RFT 26-083 Interior Renovations & Air Conditioner Upgrades at Frontenac PS

The following, issued by the Halton District School Board (HDSB) June 18, 2026, shall be incorporated in the specifications and shall form part of the proposal document for the above.

TENDER ADDENDUM NO. 1
2026.06.17

Interior Renovations and Air Conditioner Upgrades at Frontenac Public School
Halton District School Board RFT 26-083
5140 Pinedale Avenue, Burlington, Ontario

7 TYPICAL UNIVERSAL WASHROOM ELEVATIONS, FIXTURES & ACCESSORIES
A1.6 1:20

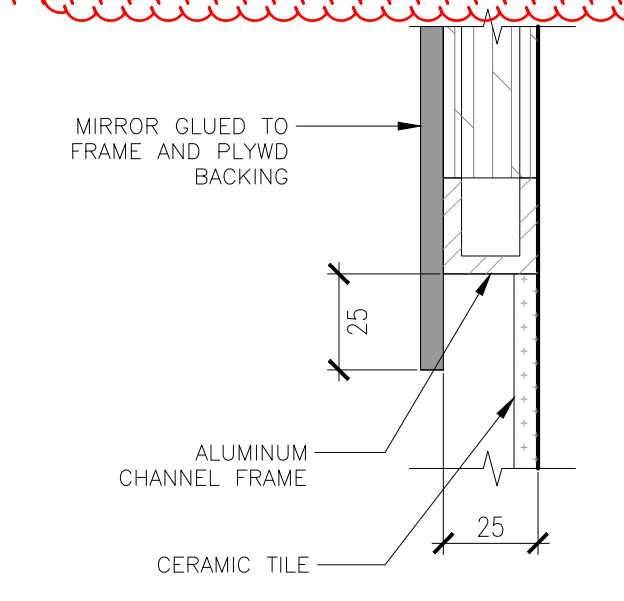
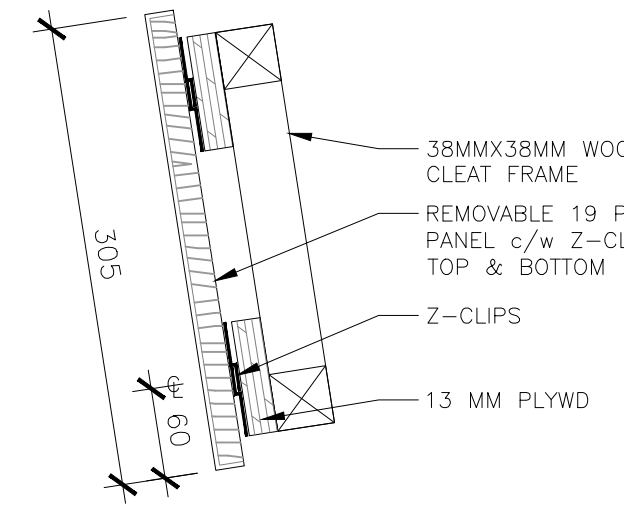
1.8: Drawing A1.6 Washroom Details & Millwork:

1. Drawing A1.6 RENAMED as Washroom Details & Millwork. See attached revised drawing A1.6 with bubbled revisions.
2. Details 5/A1.6, 6/A1.6 and 7/A1.6 relocated from Drawing A1.2. See attached revised drawing A1.6 with bubbled revisions.
3. ADD Millwork Section Details 10/A1.6, 11/A1.6 and 12/A1.6. See attached revised drawing A1.6 with bubbled revisions.

Drawing No.:
E1.5

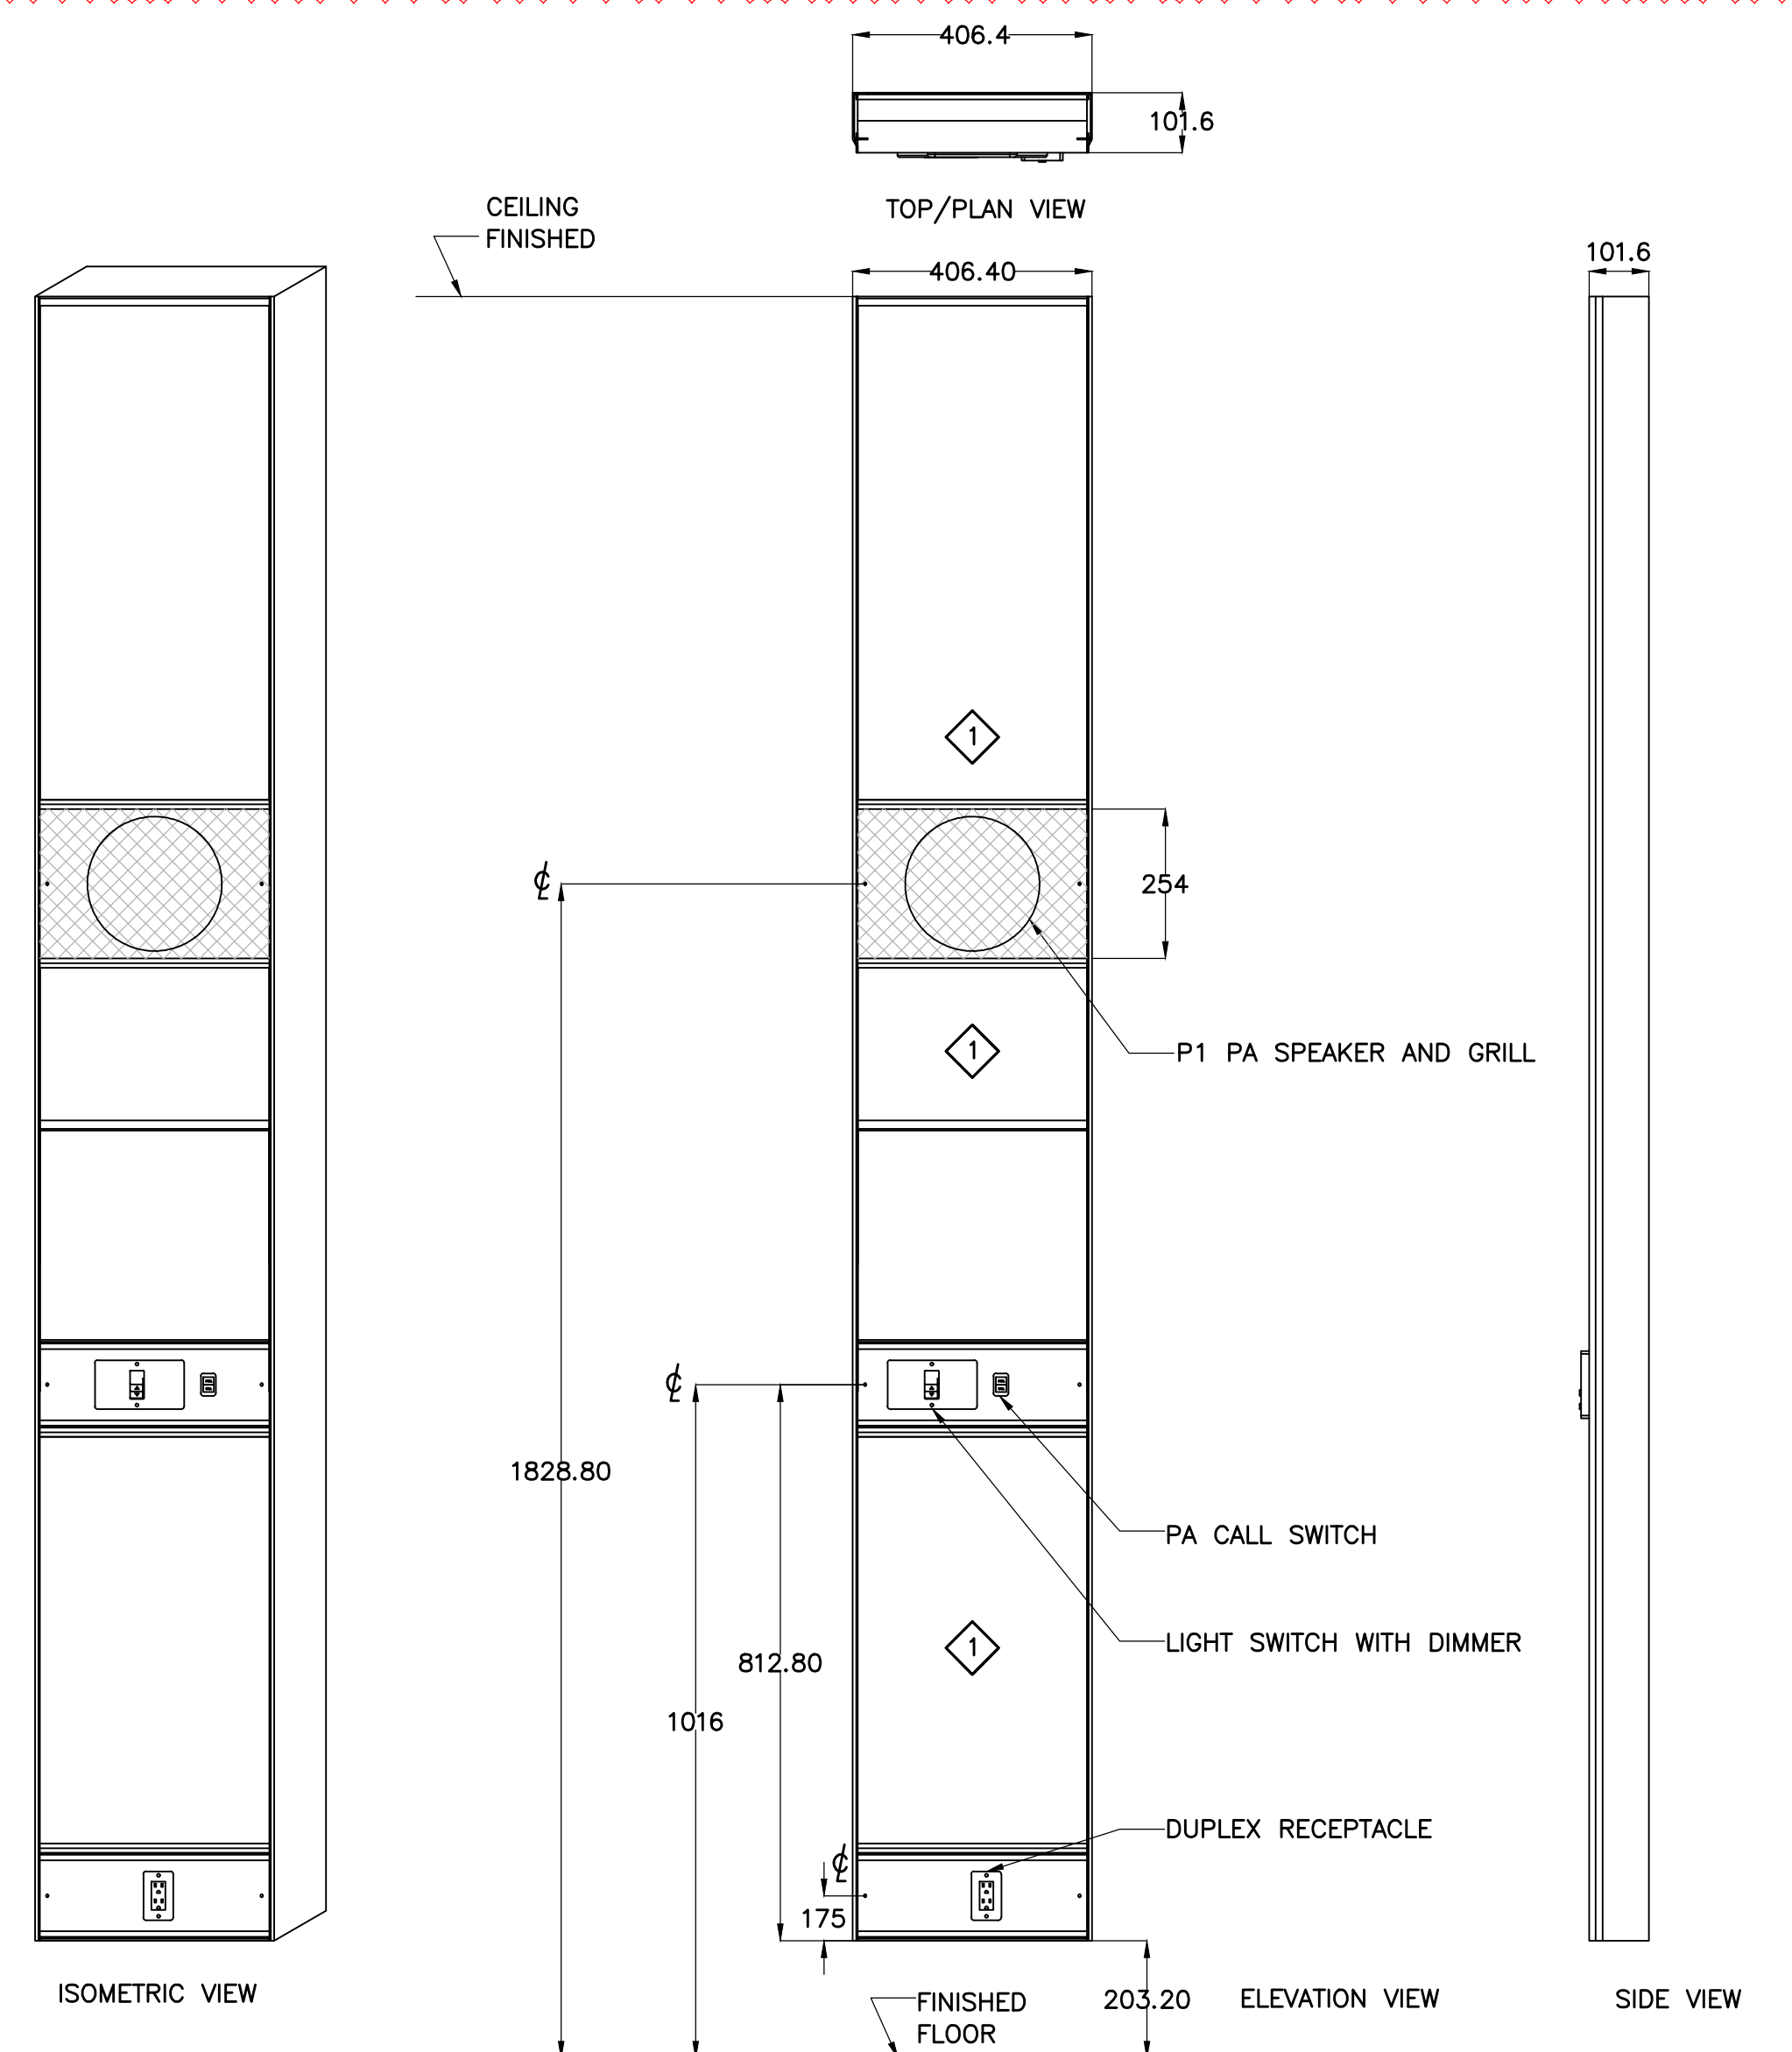
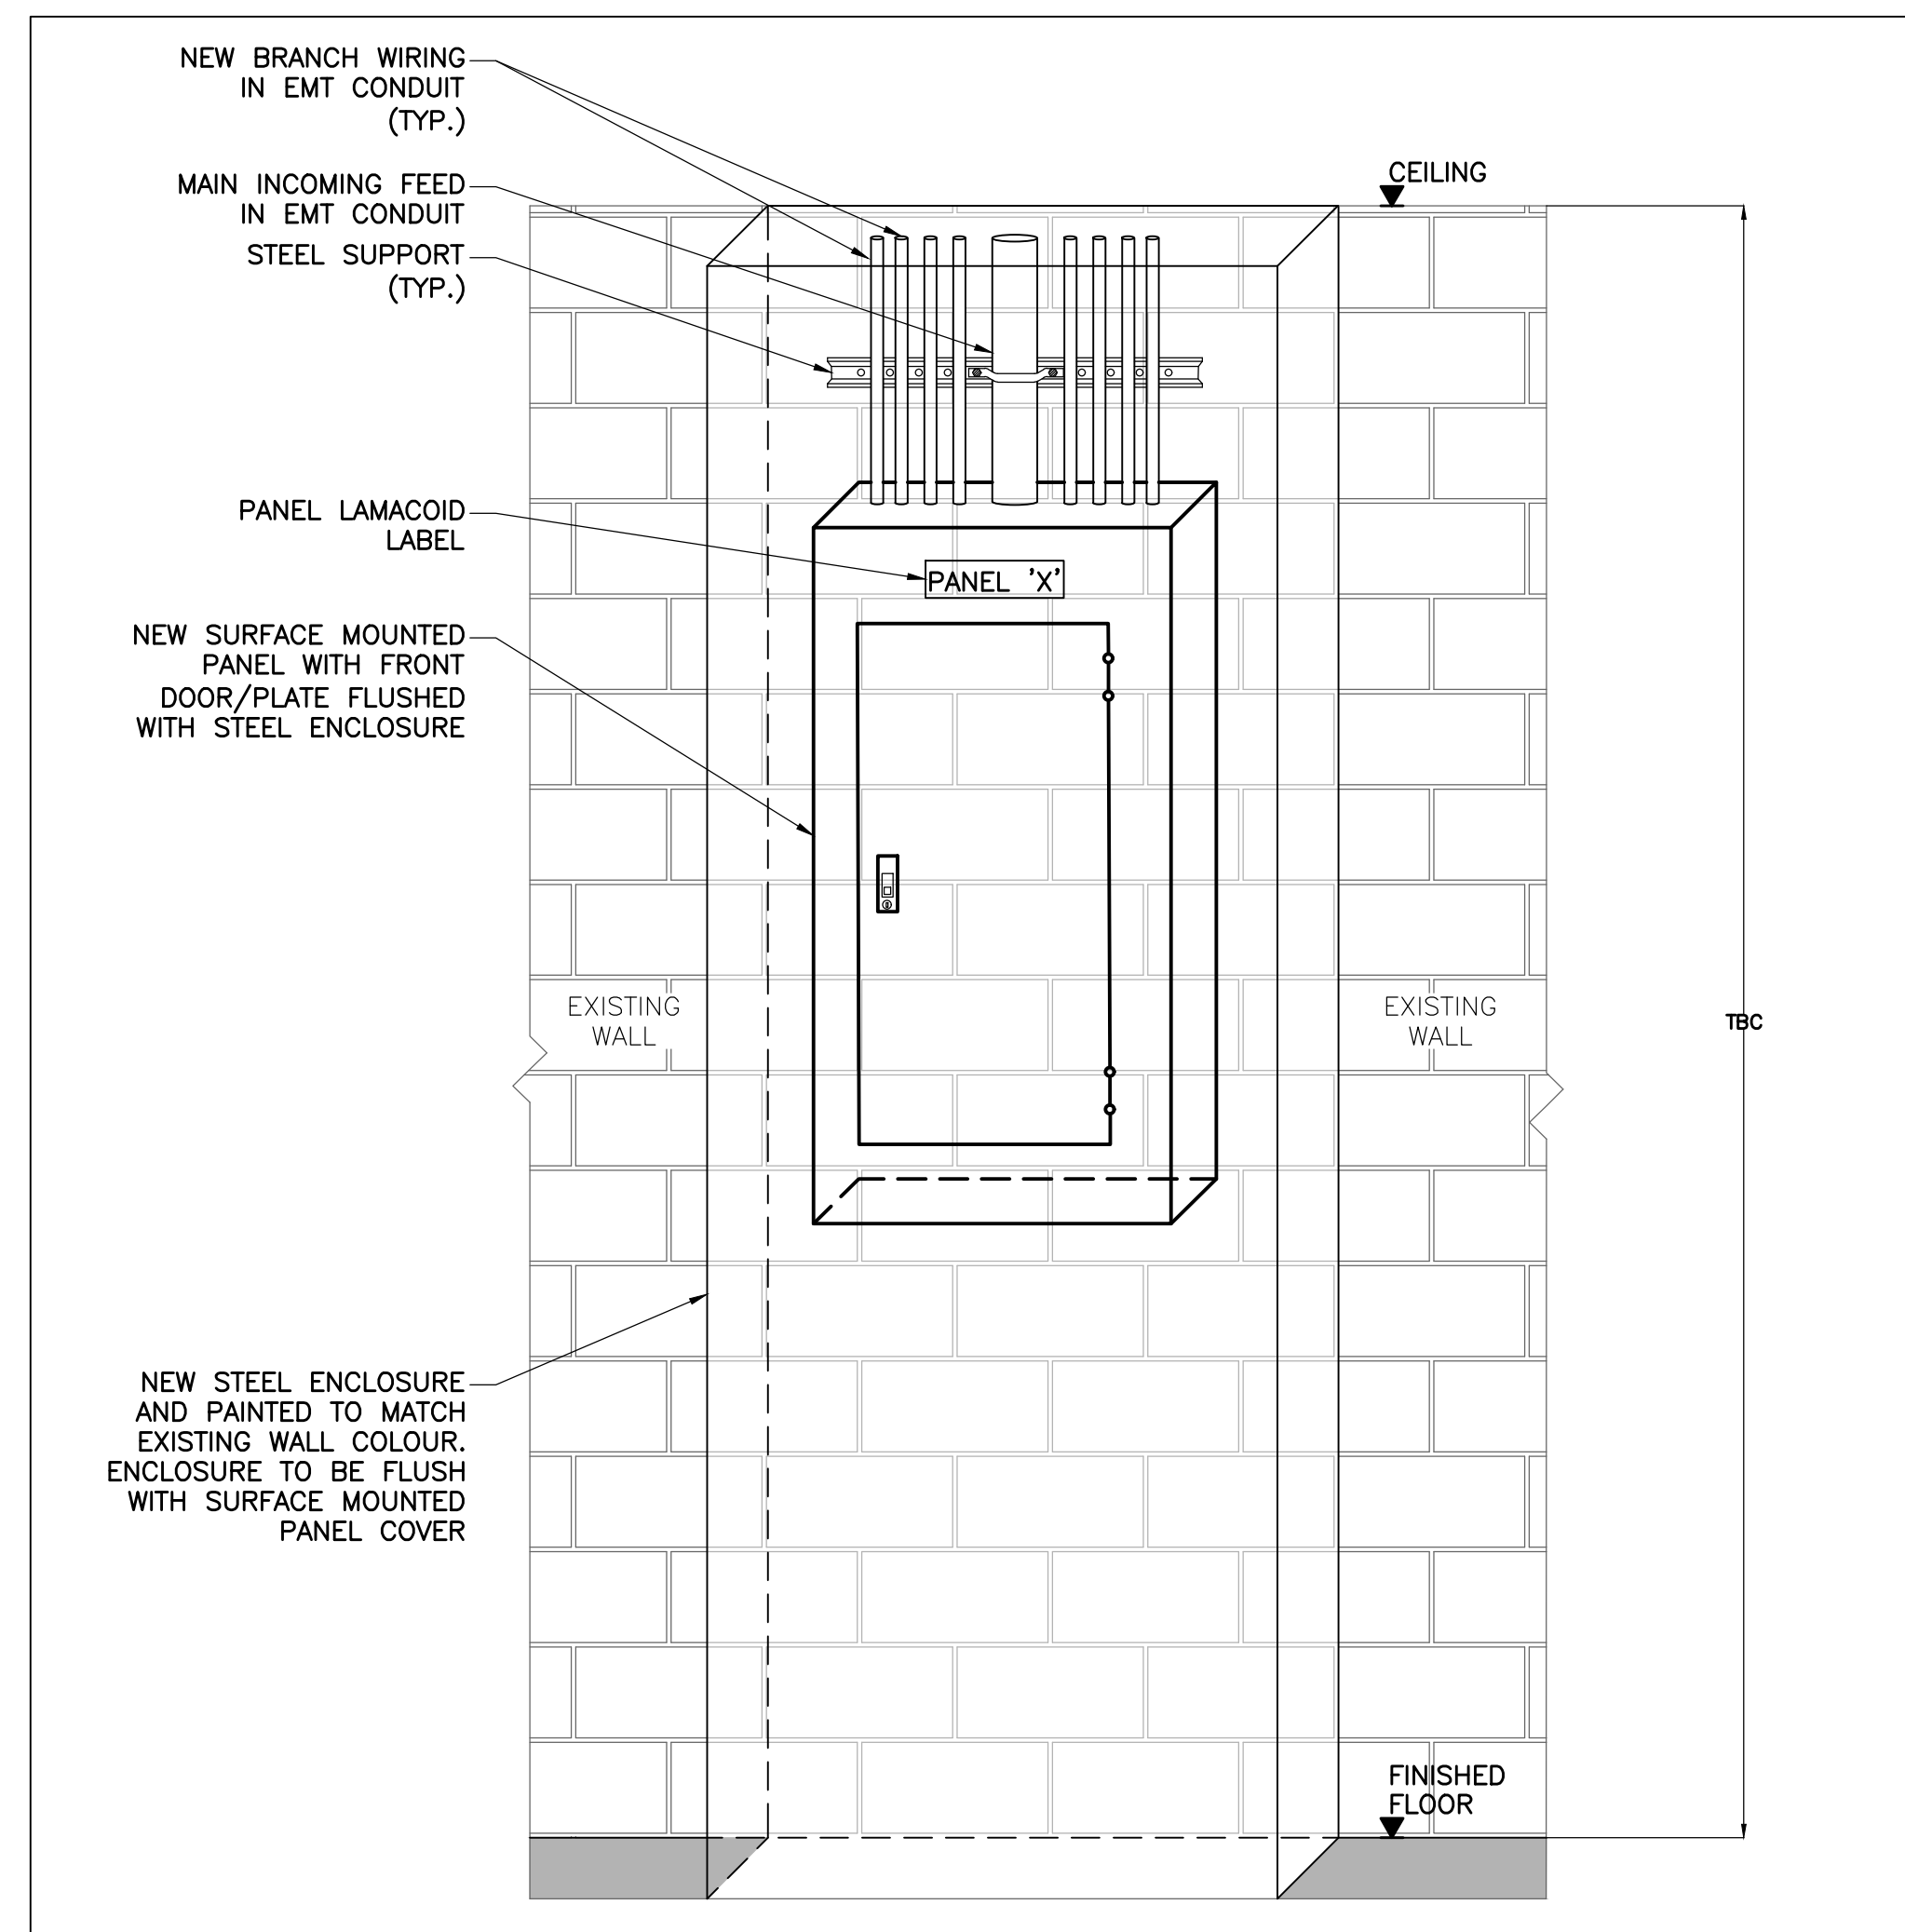
- 1.4 Refer to revised Electrical Drawing E1.5 Rev.A
 - Added new drawing sheet E1.5.
